Application Ref: NP/21/0110/FUL

Proposal Replacement Dwelling

Site Location Pen-castell, Moylegrove, Pembrokeshire, SA43 3BU

Ground Floor Plan (Scale - 1:100) House 328 sqm Garage 49 sqm

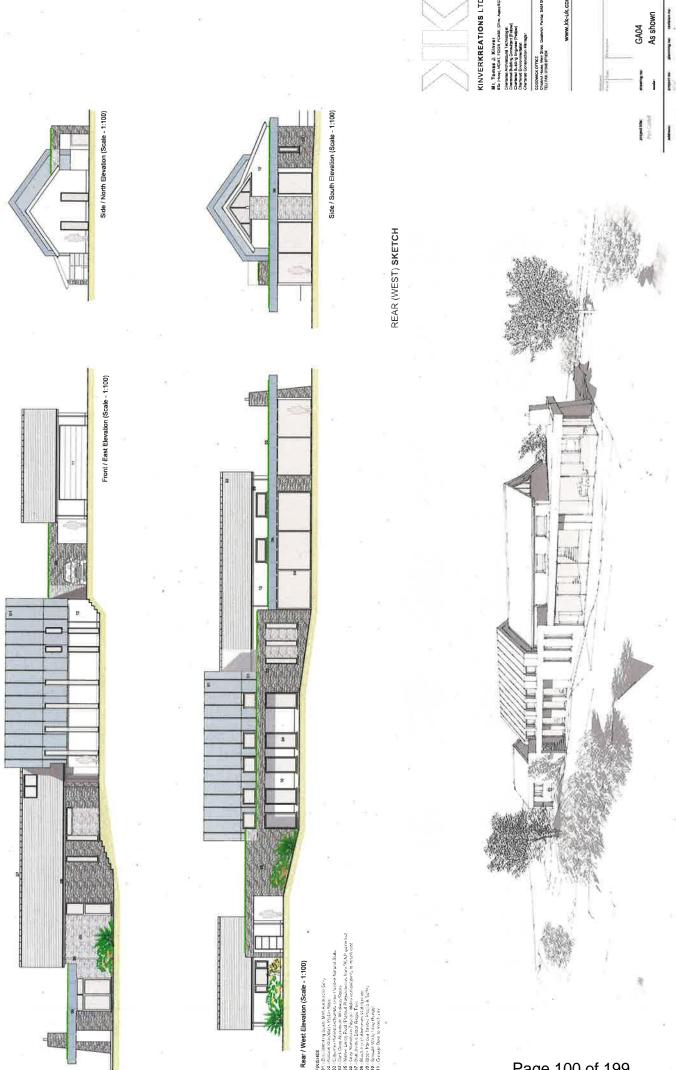
- 1. Reduction of Ridge Heights (Reduced Pitch angle of all roof slopes from 45deg to 35deg
- 2. Proposed Aluminium Clad Roof Ridge Height Reduced by 1300mm
- 3. Proposed Slate Roof Ridge Height Reduced by 990mm
- 4. Garage Roof (now slate) Roof Ridge Height Reduced by 2050mm
- 5. Garage First Floor Omitted & Garage external steps
- 6. Garage Footprint Reduced by 12sqm [650mm shorter and 950mm narrower]
- 7. Garage has been moved 1500mm closer to the proposed house
- 8. Omission of rooflight facing sea on main house
- 9. Omission of all rooflights from garage
- 10. Omission of cladding from garage elevations
- 11. Cladding Colour changed to Dark Grey (from Copper).

The raising of the roof height; the breaking up of the length of the building with different roof materials combined with the further extension of the footprint of the building and the large ground floor areas of glazing does not give rise to a cohesive design which is considered to be sympathetic to this location. The house will be much more visible on the landscape by being raised to two storey, and also visible from Ceibwr Bay. The proposal is considered to be likely to cause significant visual intrusion and to look very much at odds with the surrounding landscape and is therefore contrary to Policies 8 and 14.
